China Patent Agent Docket: FPEL04150018US

REMARKS

AMENDMENTS TO THE DRAWINGS

APPENDIX 2: Annotated Sheet 1/6

FIG. 1A

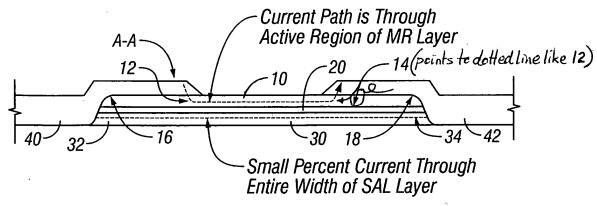
In FIG. 1A of drawing sheet 1/6, please point the line from reference numeral "14" to the

dotted line within layer 10 (e.g., in the same way that the line from reference numeral "12"

points to the dotted line in layer 10 in FIG. 1A).

In FIG. 1B of drawing sheet 1/6, please add "ABS" to reference numeral "60" and delete

reference numeral "40."

16 30 20 34 (as in FIG. 1A) 32 FIG. 2

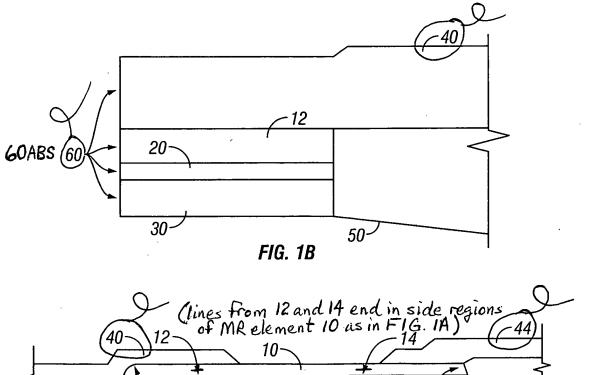
In FIG. 2 of drawing sheet 1/6, please delete reference number "44" and move reference

number "40" in FIG. 2 to the same position that it occupies in FIG. 1A. Also please end the lines

from reference numerals "12" and "14" in FIG. 2 in the respective side regions of MR element

10 (as the lines from reference numerals "12" and "14" end in respective side regions of MR

element 10 in FIG. 1A)...
